CITY AND BOROUGH OF WRANGELL
Wrangell Water Treatment Plant Project
Addendum No. 6

August 2, 2023

1. Revised Drawings M-502, M-503, M-504, M-701, M-702, M-703, M-906
2. Revised Specification 46 33 83

ACID ROOM - SECTIONS

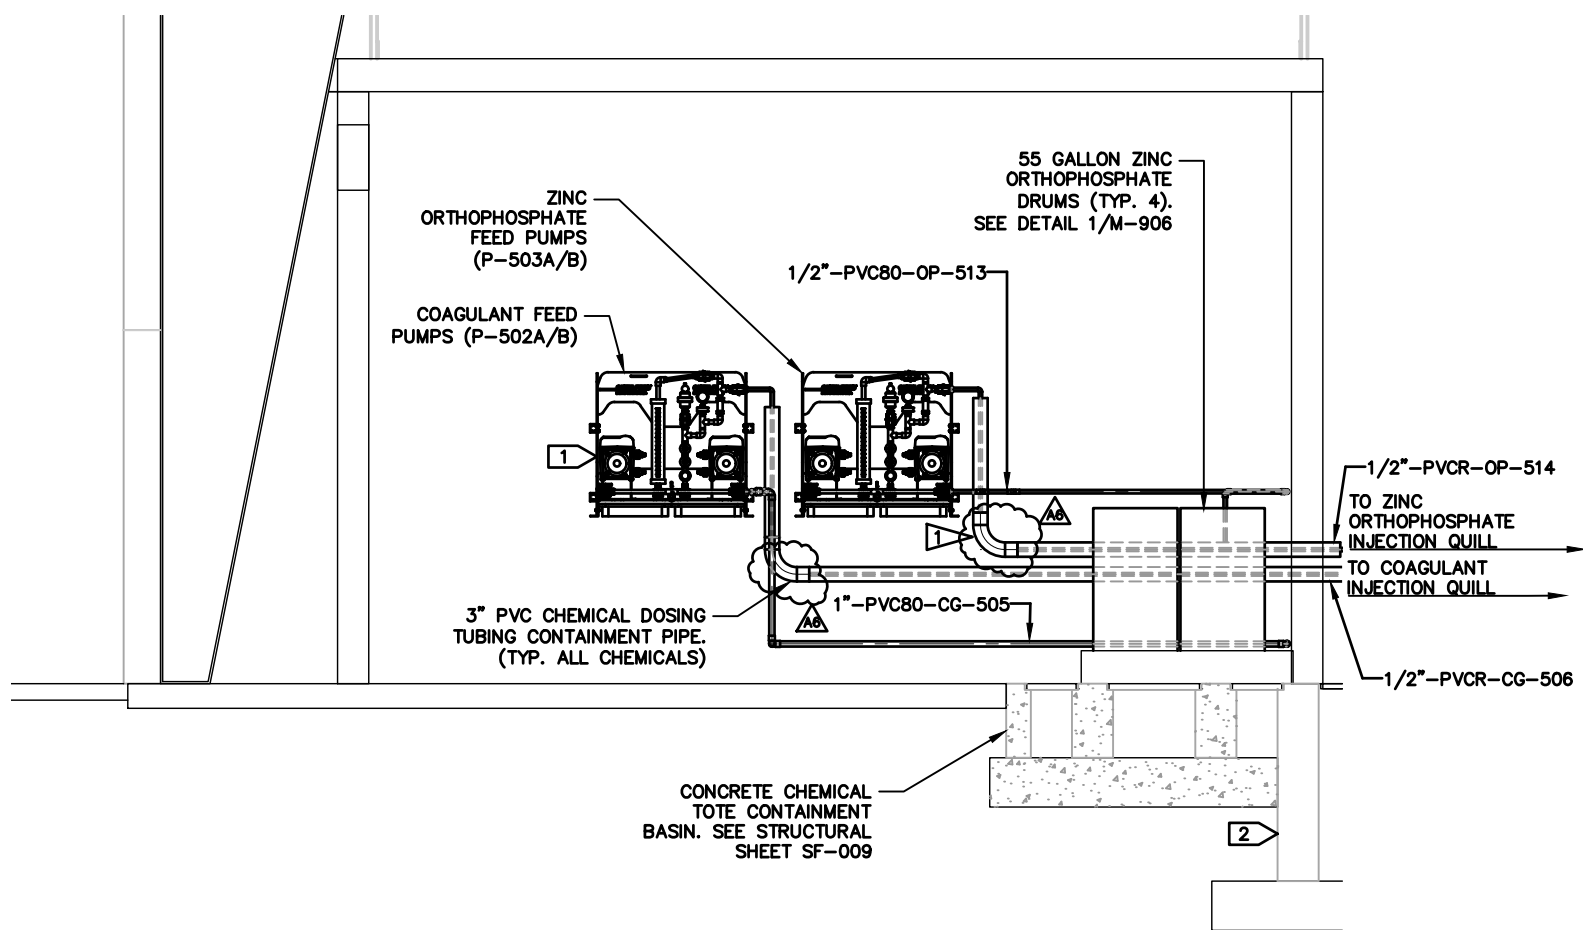
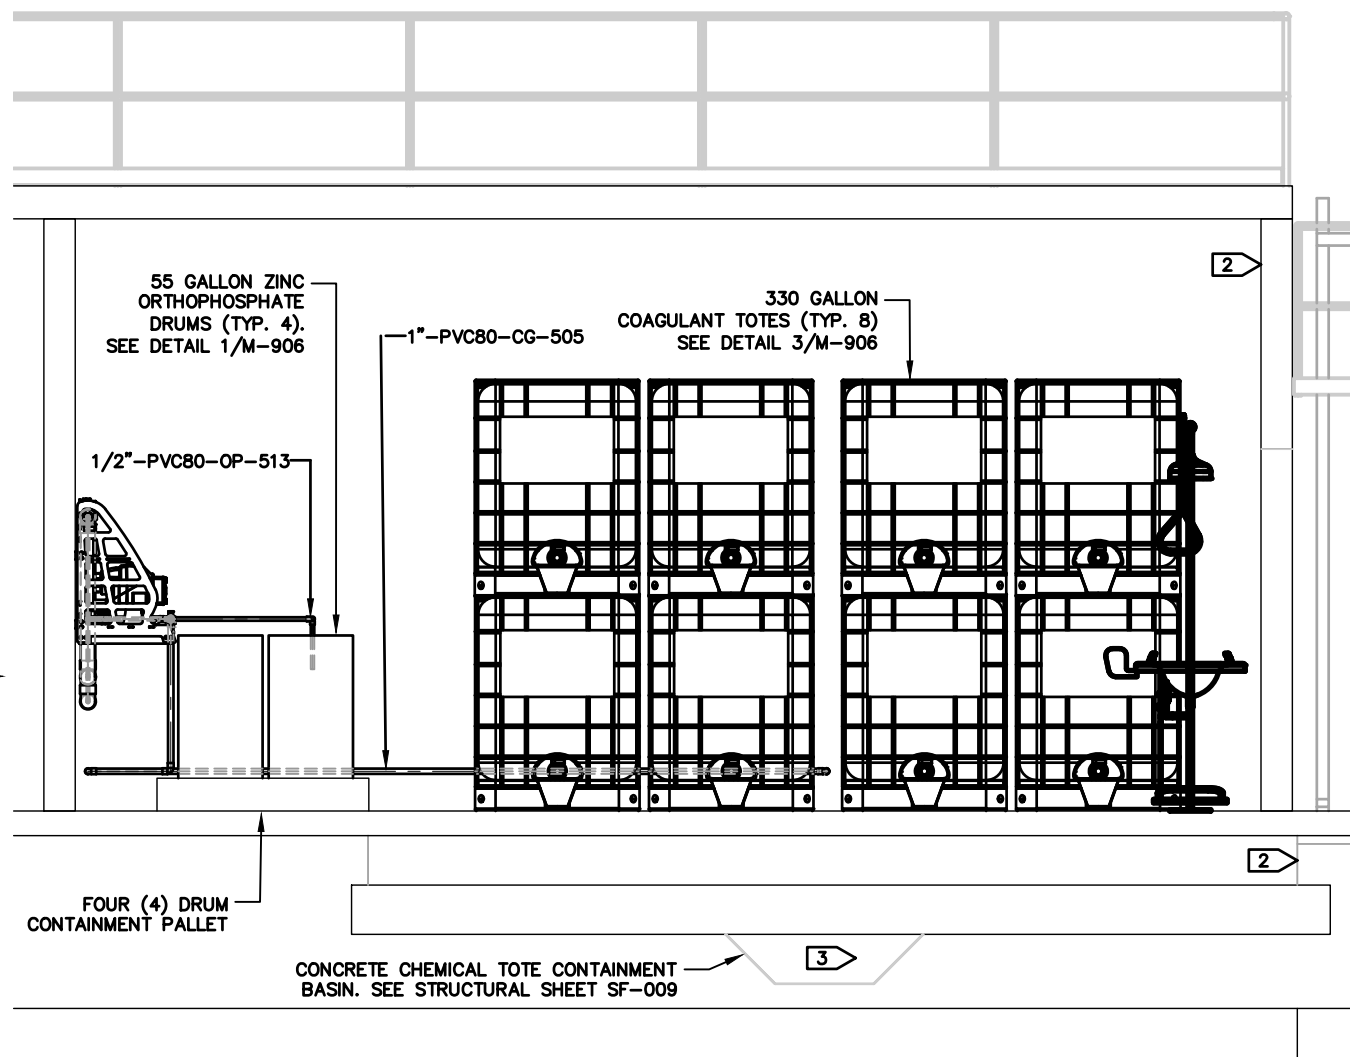
- a) Spec 46 33 83 2.4.D Chemical Transfer Tubing and detail 4/M-906 may have some constructability issues related to the secondary containment piping shown as 3" PVC Schedule 80 elbows and tees and the use of 1/2" continuous tubing. The exterior chemical containment piping shown on civil page C-104 is illustrated as swept PVC conduit which would lend itself well to pulling in 1/2" continuous tubing. On drawing M-700 it is illustrated as 3" PVC changing to HDPE containment pipe with molded HDPE water pipe elbows which is very hard on the tubing. Construction note 2 on M-700 indicates the use of swept bends underground which is interpreted as using 3" coiled HDPE rather than multi segment fabricated HDPE elbows. Installing continuous tubing (reinforced PVC hose) inside tight radius PVC schedule 80 water pipe fittings as depicted at the above ground locations on this and other M drawings seems impossible and may shorten the working life of the tubing. This is especially true where the chemical lines have multiple elbows to route the tubing from the Base and Acid rooms to and in the piping trenches to reach the various injection points. What is the intended containment pipe supposed to be in spec 46 33 83? How are the tees depicted on M-906 intended to facilitate the installation and maintenance of the chemical tubing? Are the tee branches intended to be fitted with removeable caps or plugs?

- a) Any new chemical tubing inside the new WTP and existing control room shall be 1/2" reinforced PVC tubing inside 3" or larger PVC conduit with swept bends. Fittings shall be socket type with solvent welds. All chemical transfer tubing shall be continuous with no joints. Please see the updated drawings and specifications for clarification.
Regarding constructability, larger nominal diameter swept bends and fittings (4" and larger) may be used with reducing bushings or reducers as necessary to facilitate easier installation. Per the notes on the M-drawings, the chemical tubing and containment pipe is to be field routed. Bends should be minimized and adequately spaced.
The access tees on M-906 were intended to allow the contractor to access the chemical tubing if the contractor elected to install all the containment pipe prior to installing the tubing. When using PVC conduit, the tees are not required. If tubing access is necessary during construction, 2-inch diameter holes may be drilled in the secondary containment pipe periodically. These holes are not required if installation and maintenance can be performed without.

- GENERAL NOTES:**
- SEE PROCESS AND INSTRUMENT DIAGRAMS (PI SHEETS) AND SPECIFICATIONS FOR PERISTALTIC METERING PUMP SKID REQUIREMENTS.
 - STRUCTURAL ELEMENTS SHOWN FOR REFERENCE ONLY. SEE STRUCTURAL SHEETS FOR DETAILS.
 - CONTRACTOR SHALL SUPPLY THREE (3) PORTABLE SUMP PUMPS CAPABLE OF FITTING INSIDE SECONDARY CONTAINMENT SUMP: ONE (1) FOR ACID SERVICE, ONE (1) FOR BASE SERVICE, AND ONE (1) FOR GENERAL WATER/WASTEWATER SERVICE.
- CONSTRUCTION NOTES:**
- FIELD ROUTE CHEMICAL TUBING THROUGH MAIN PROCESS TRENCH TO CHEMICAL INJECTION POINTS. SEE PROCESS AND INSTRUMENT DIAGRAMS (PI SHEETS). ALL PVC CONTAINMENT PIPE BENDS SHALL BE SWEPT.
